WATERSTONE, Fil. No. 4-Site Plan

Technical Correction-Response to Comments

Re: Waterstone Filing No. 4
Site Plan Comments and Technical Corrections
Aurora, Colorado

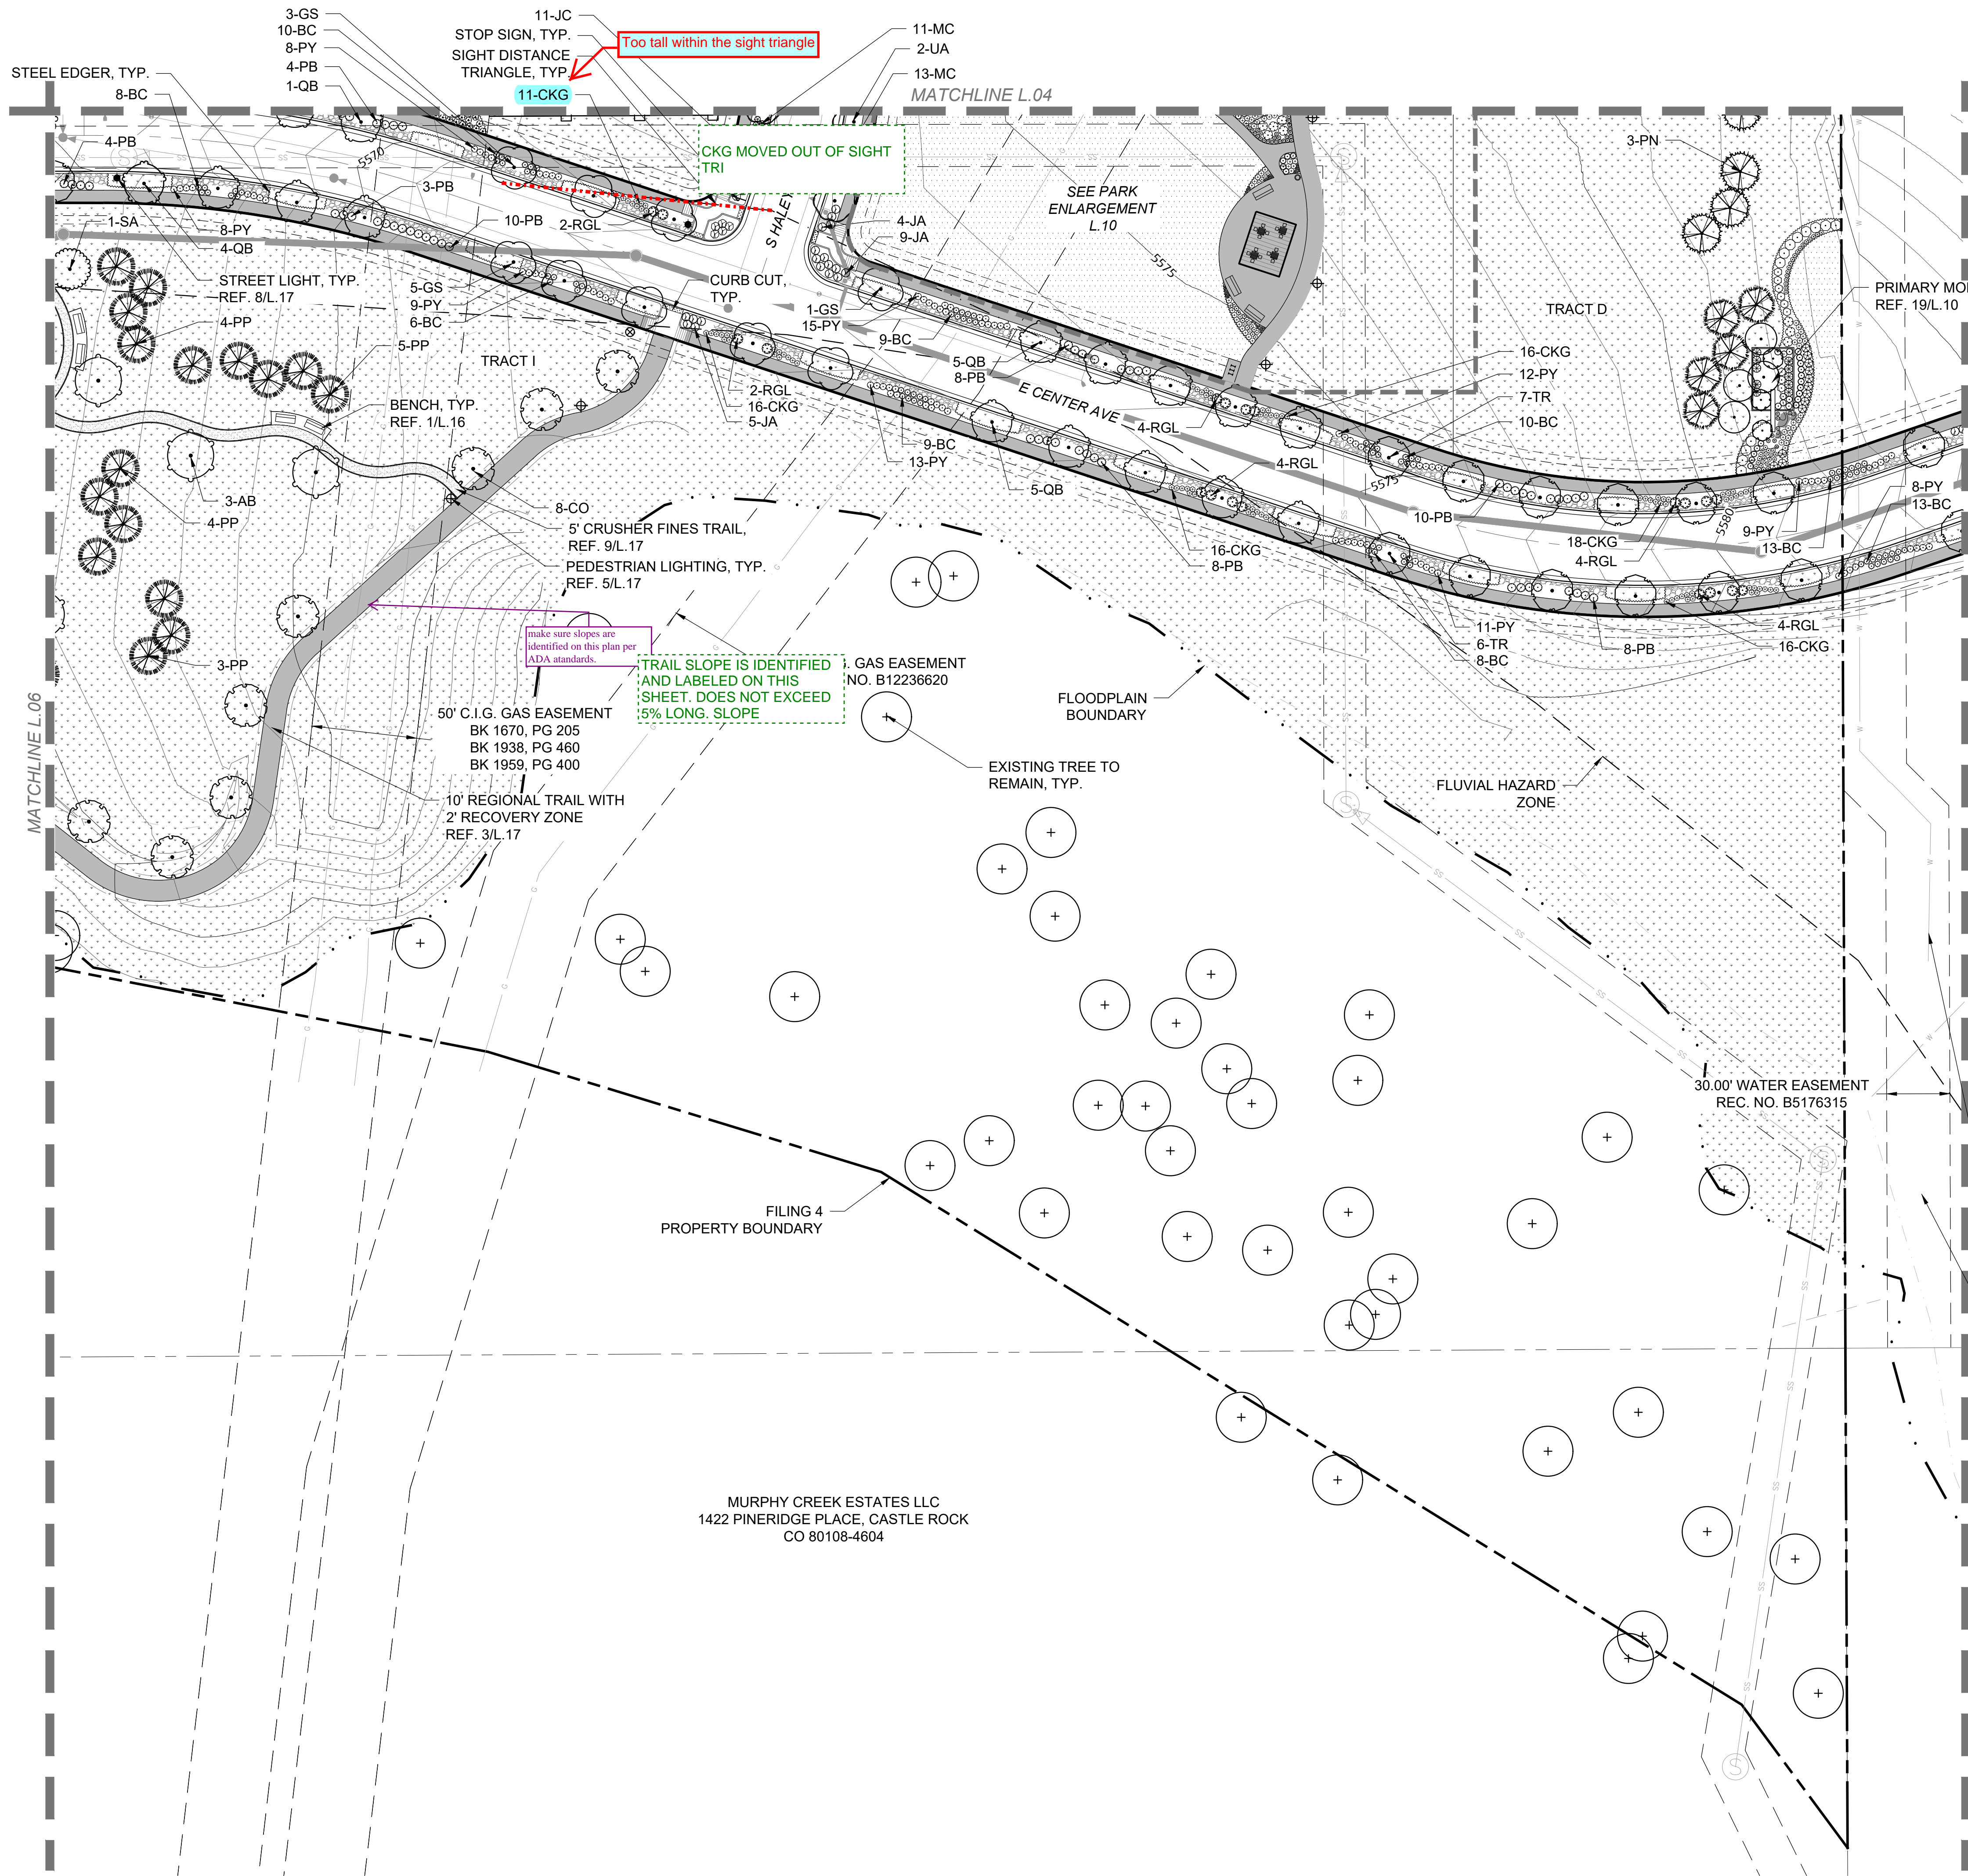
Add a note and/or a call out for the mulch treatment within the curbside landscape.

Label the pond as detention pond "A"

TYPE OF MULCH FOR CURBSIDE LDSCP IS NOTED IN THE LEGEND AND CALLED OUT ON PLANS

1 TRACT D PARK ENLARGEMENT (POCKET PARK #1)

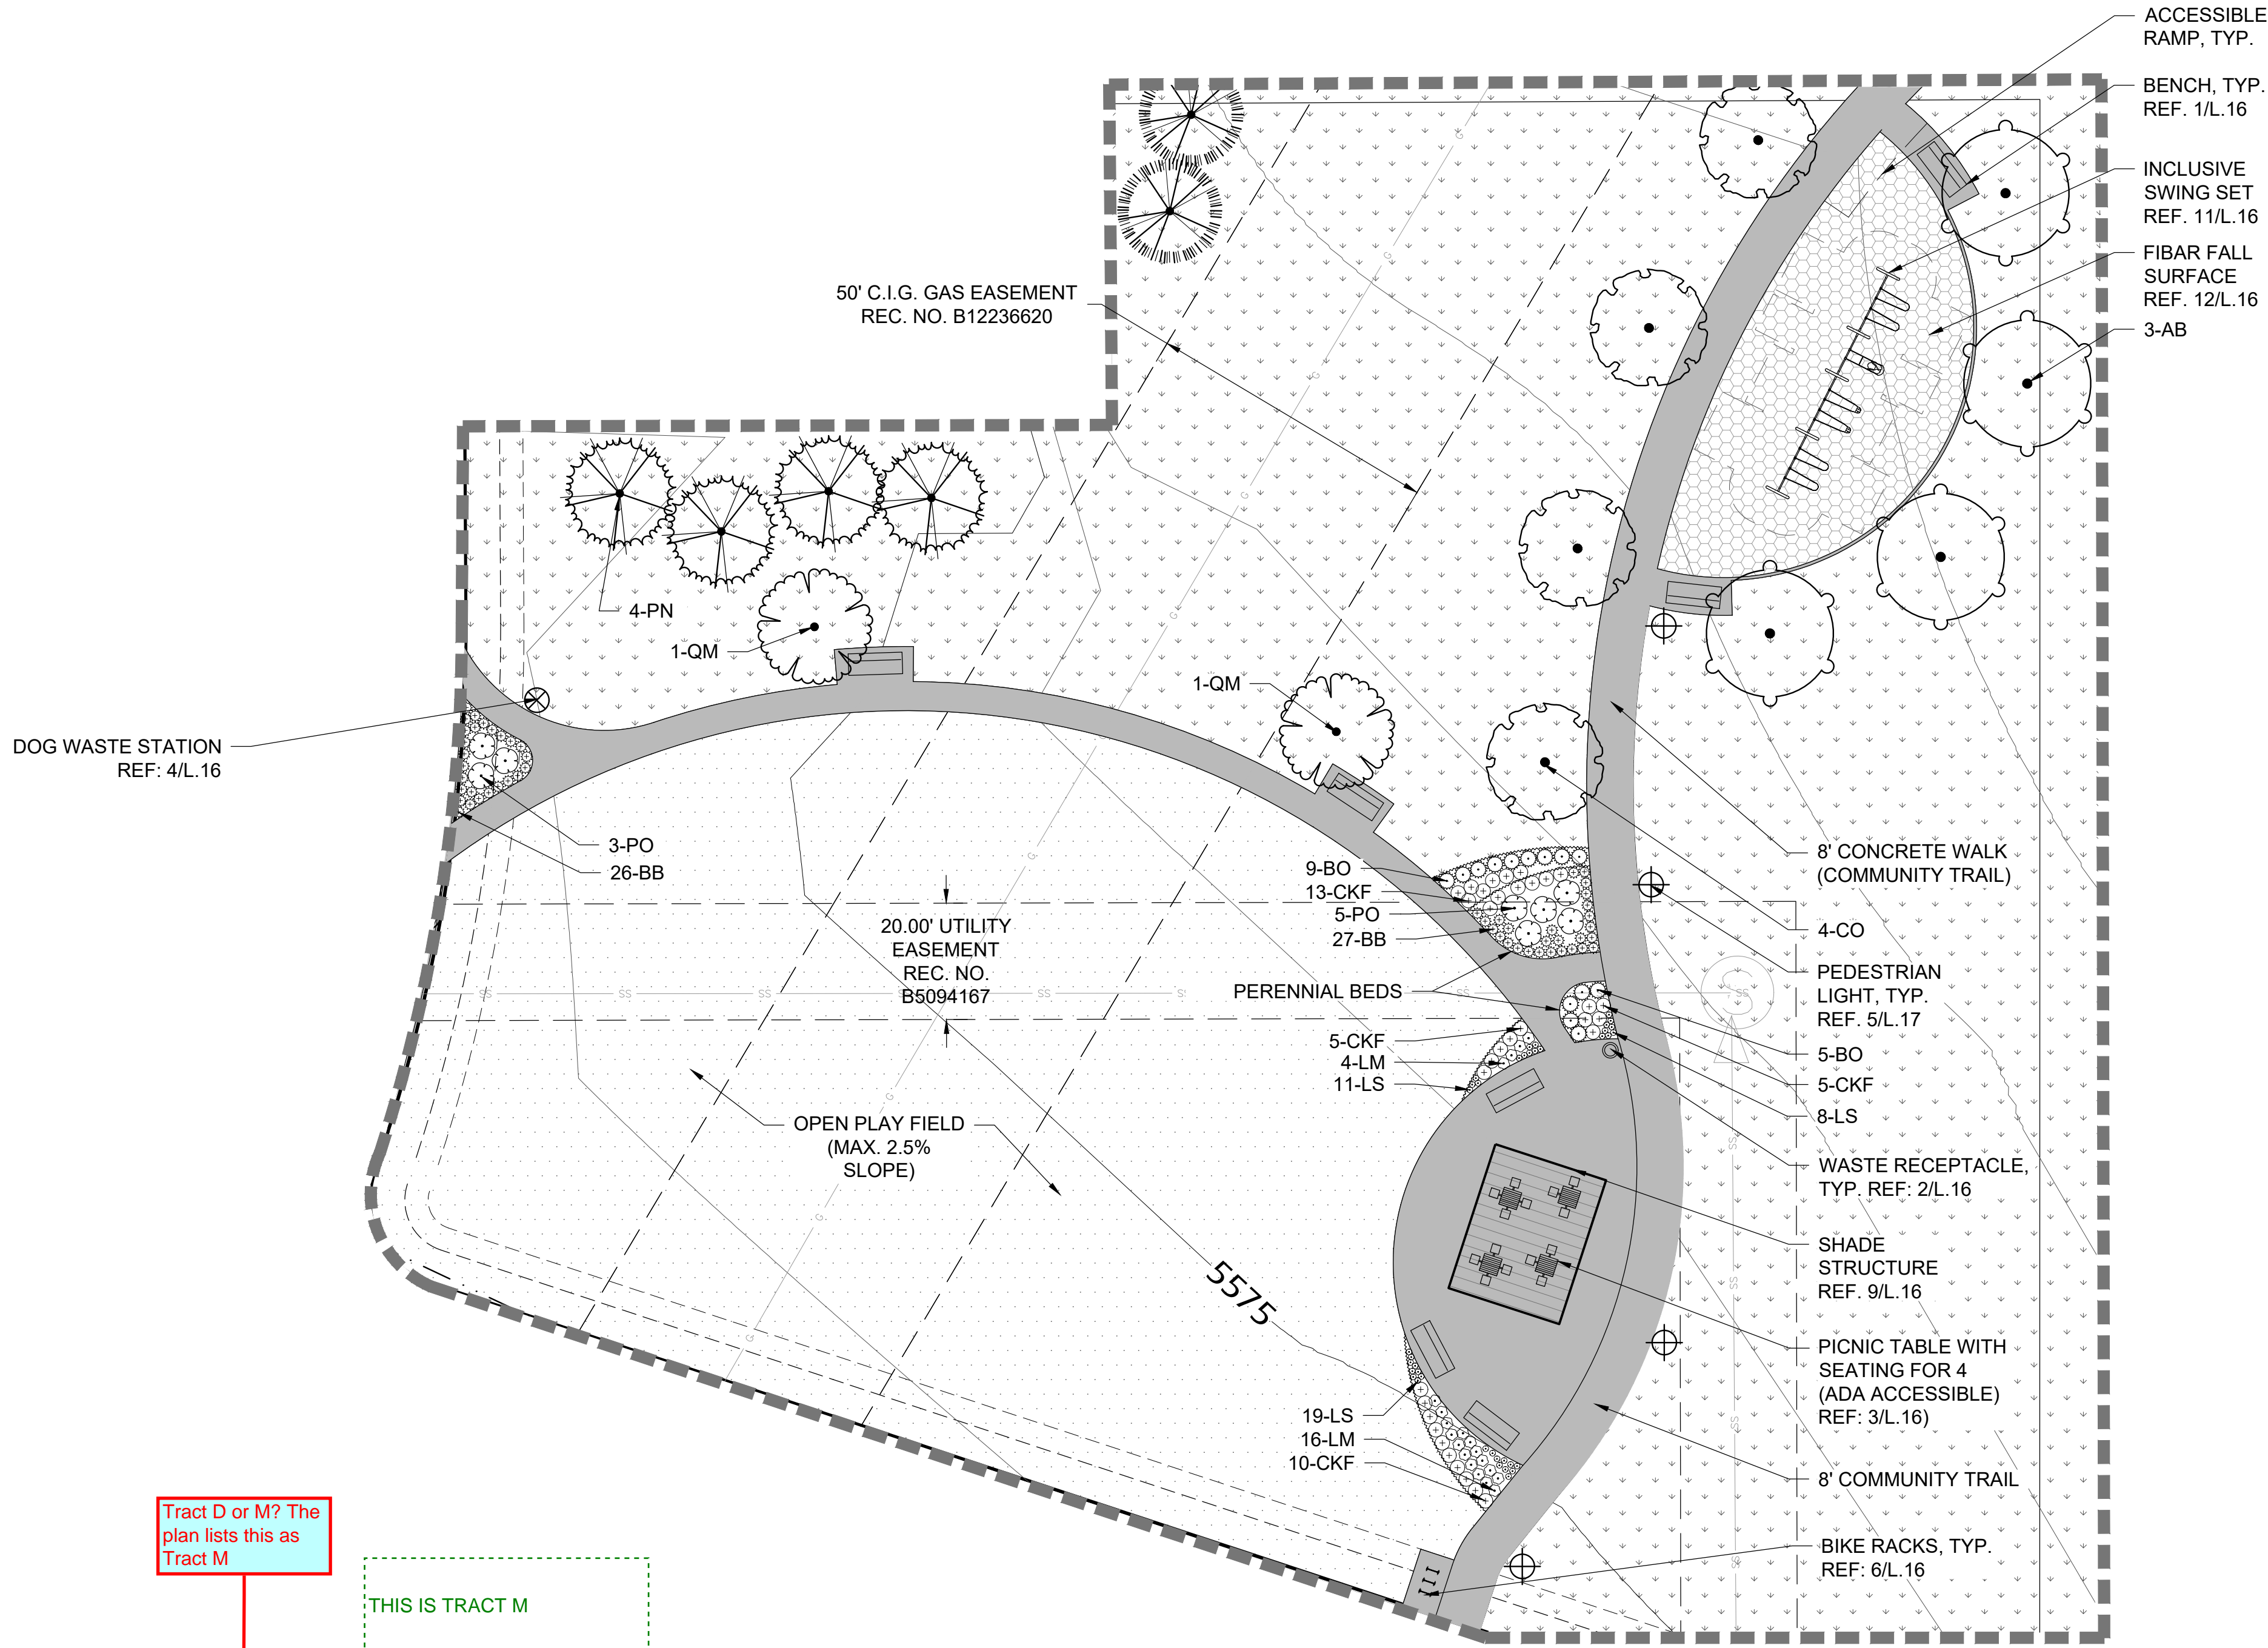
Tract D or M? The plan lists this as Tract M

THIS IS TRACT M
